NOTICE TO CONTRACTORS BIDDING THIS PROJECT

Project Title: Building and Site Improvements at 6741 Downing Avenue, Bakersfield, CA

Contract No: 26016

ADDENDUM No. 5

JOB 7006	
DP AC/YN	A811B
PM GUF

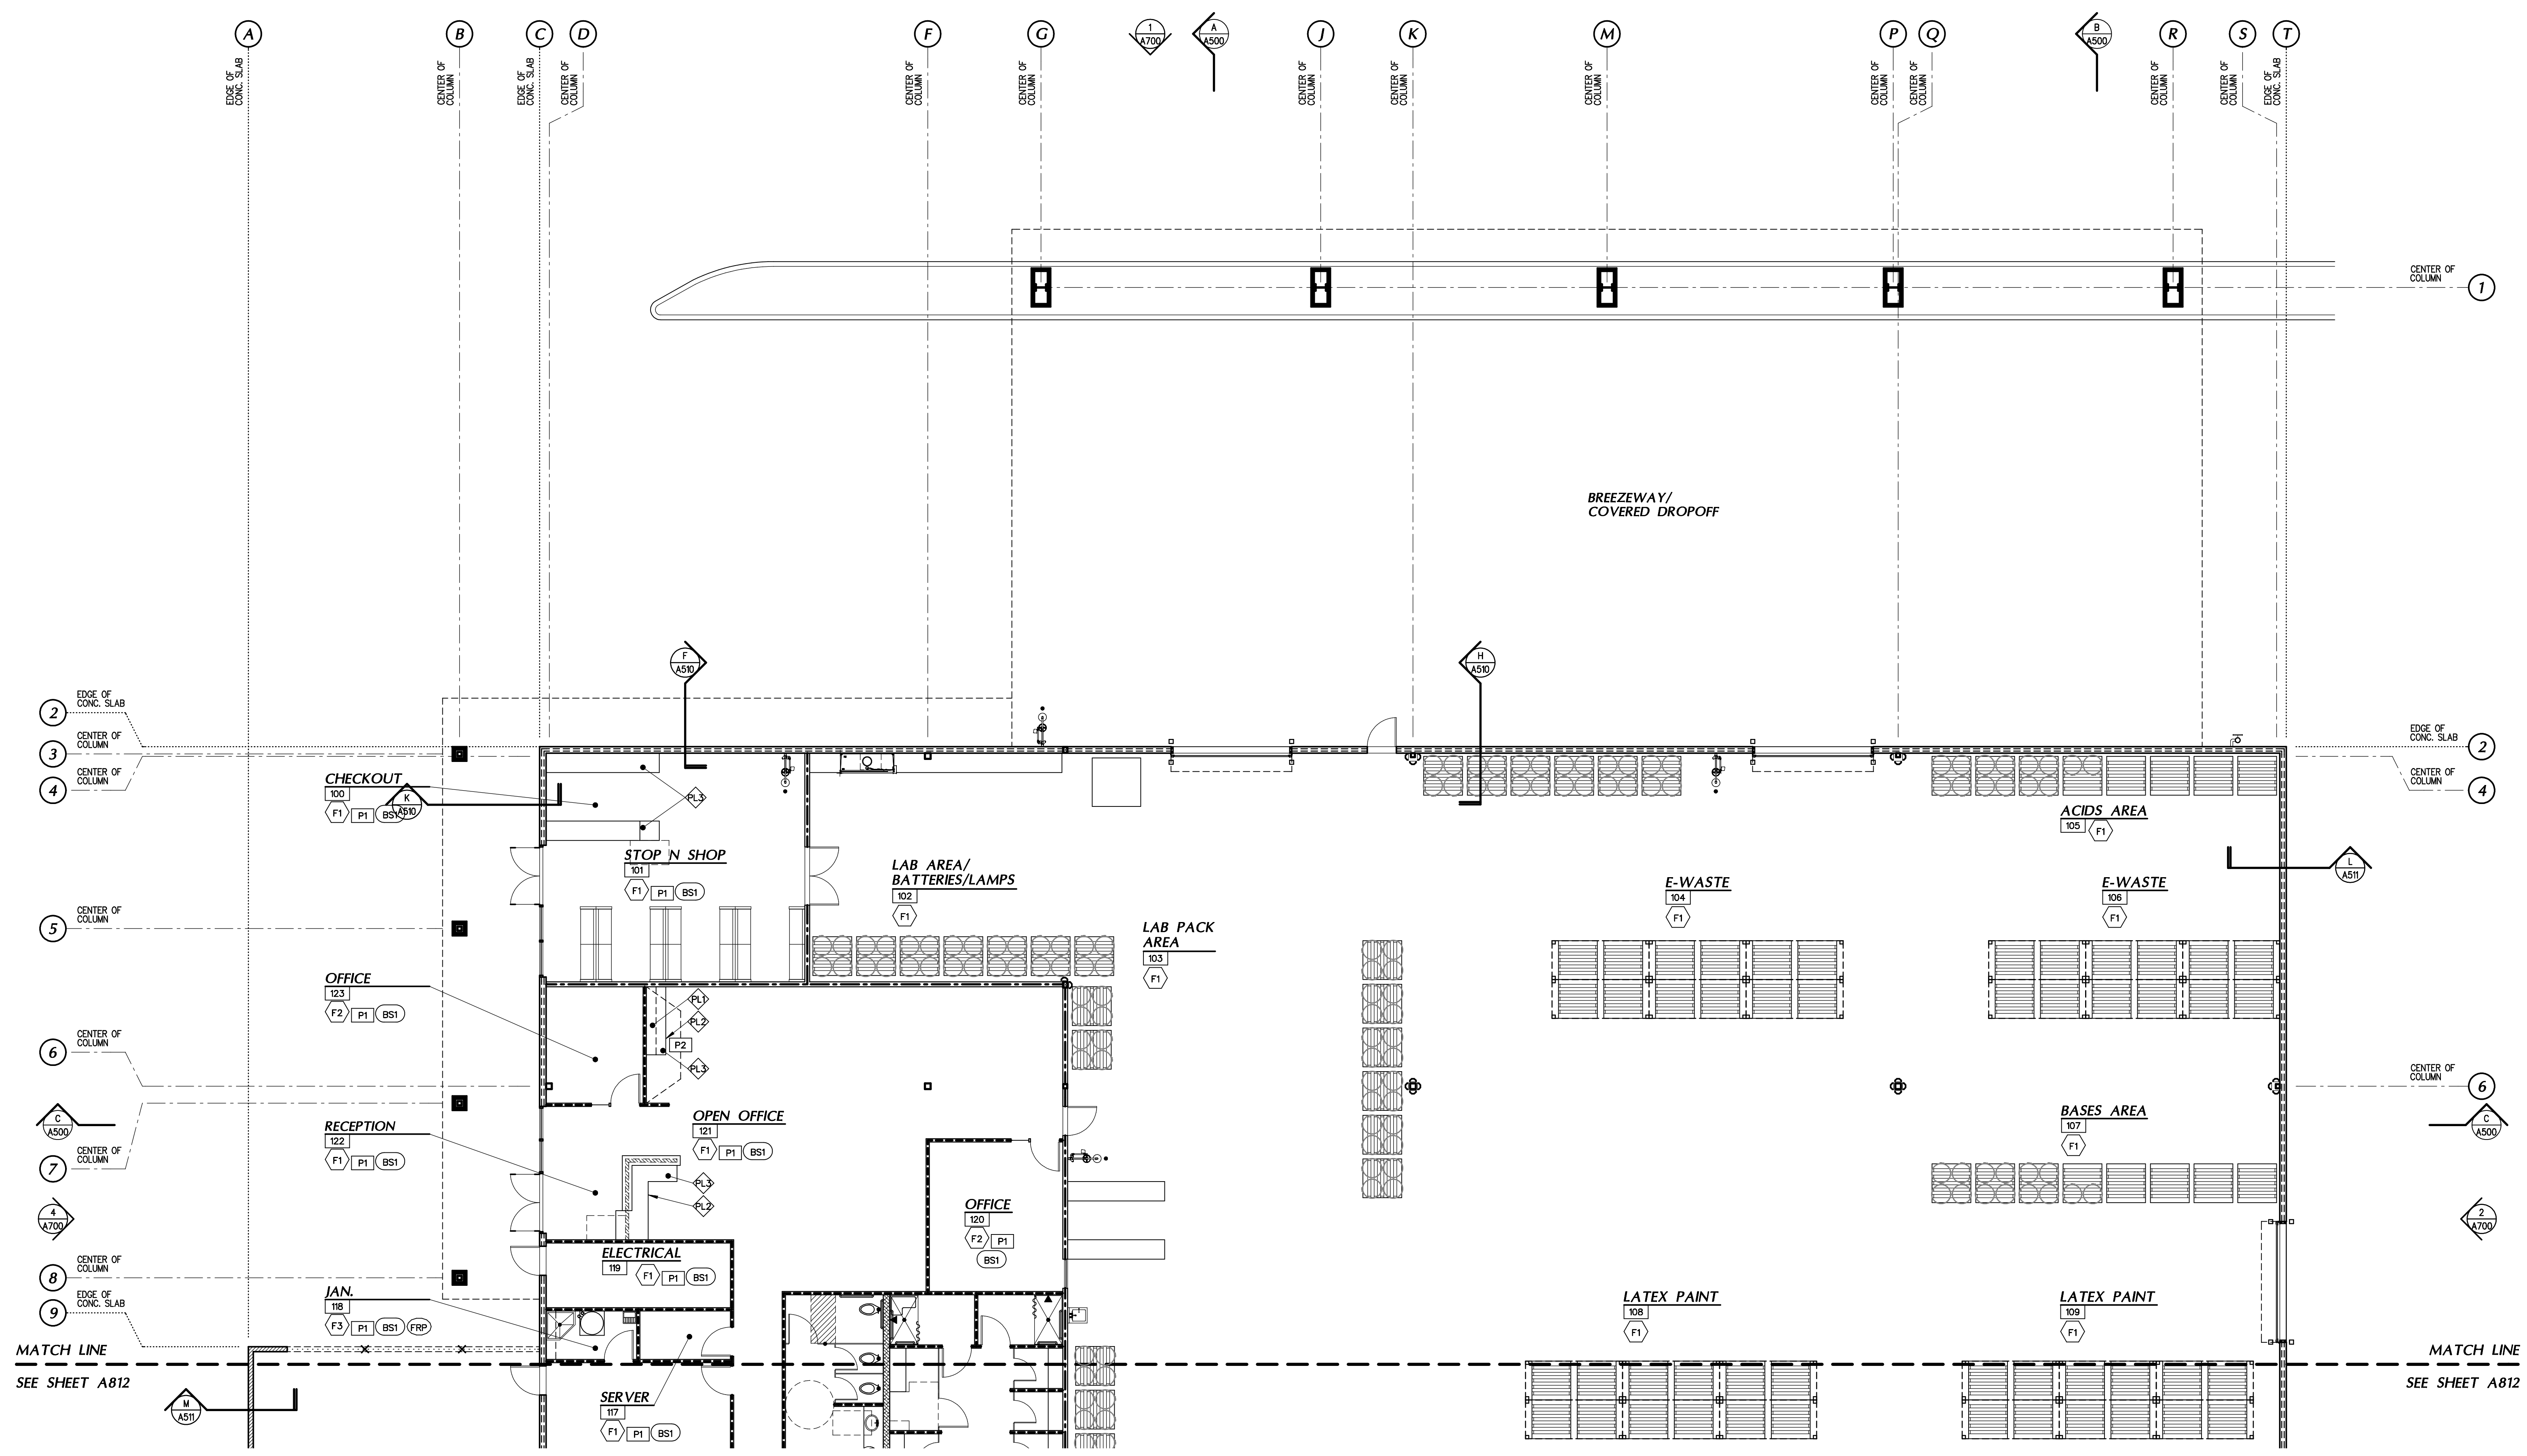
- l. Sheets A811A and A812A have been replaced with sheets A811B and A812B. Window covering information has been added. Wall tile sizes have been added. Concrete sealer information has been added. The revised sheet is attached to this addendum.
